Product Change Notification - SYST-04GTSX528

ERRATA - PIC32MK Motor Control and General Purpose Errata and Data Sheet Clarification

Description of Change: 1) Updated verbiage for Silicon Issue 39. (UART). 2) Added Silicon Issues: 55. (PMD Bits) and 56. (DAC) 3) Removed Silicon Issue 6. (Reserved) and 17. (Reserved).

PIC32MK General Purpose and Motor Control (GP/MC) Silicon Errata and Data Sheet Clarification

FIGURE 1: Posc CRYSTAL CIRCUIT

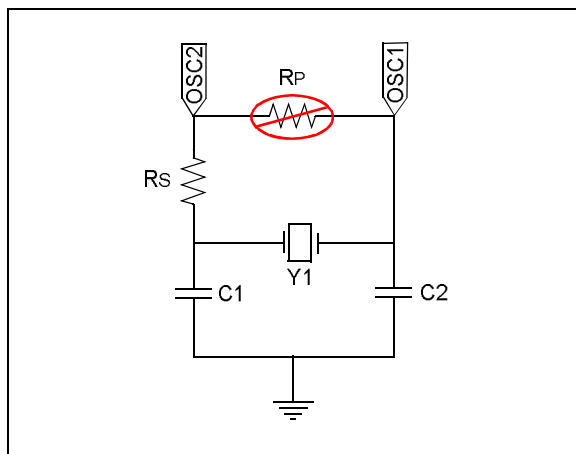
The Posc supports only specific crystal operation, as provided in [Table 1](#).

The Primary Oscillator (Posc) has been characterized to operate at 8 MHz and 12 MHz when the circuit shown in [Figure 1](#) is implemented and the operating conditions provided in [Table 1](#) are met.

2: A parallel resistor (RP) should not be used to increase the gain of the Posc.

**FIGURE 2: RESET SUPERVISOR
CIRCUIT**

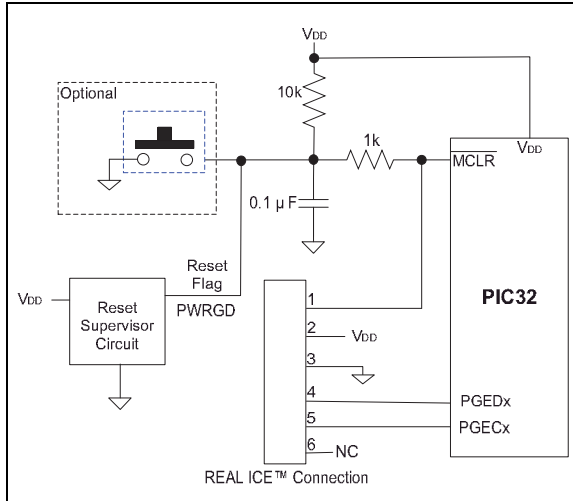
On a BOR event, $V_{POR} < V_{DD} < V_{BOR}$, a Reset is not generated when the BOR threshold is reached. System clocks will stop with all I/O pins functions frozen in their present state until either VDD falls to V_{POR} or VDD returns to above V_{BOR} . The user must assess if this VDD brown-out condition and the resulting frozen I/O pin state has an adverse effect on their application (UART, PWM, I/O, OC, etc.).

Use an external Reset supervisor/monitor (see Figure 2). Some LDO regulators, as listed in Table 4, have an embedded reset supervisor included. The required minimum reset trip voltage of the supervisor should be at least $(V_{BOR} + 0.5V)$ with the SMCLR bit (DEVCFG0<15>) = 0 and the BORSEL bit (DEVCFG2<29>) = 1 in the Configuration Words. This means that the minimum VDD operating voltage of the application needs to be above the reset supervisor maximum trip voltage at $[\text{Reset Trip (max)} + 0.2V]$, (i.e. $\text{Application VDD(MIN)} = \sim(V_{BOR} + 0.5V + 0.2V)$). The reset supervisor should have an open drain output so as not to interfere with the MPLAB programming/debug tools. This workaround assures that MCLR will generate an internal POR and reset the I/O pins before the V_{BOR} trip point.
